VISION PROFILE EXTRUSIONS

Sample Approval Form

Die #: 15745
Description: Siding Finish Trim - Exterior (3/8" Panels)

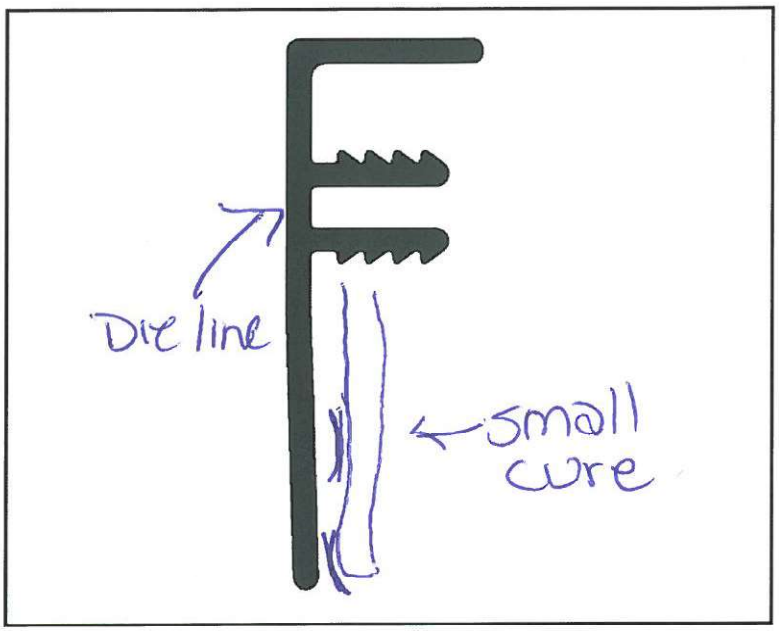
Comments: Face needs to be straighter
Die line needs improvment.
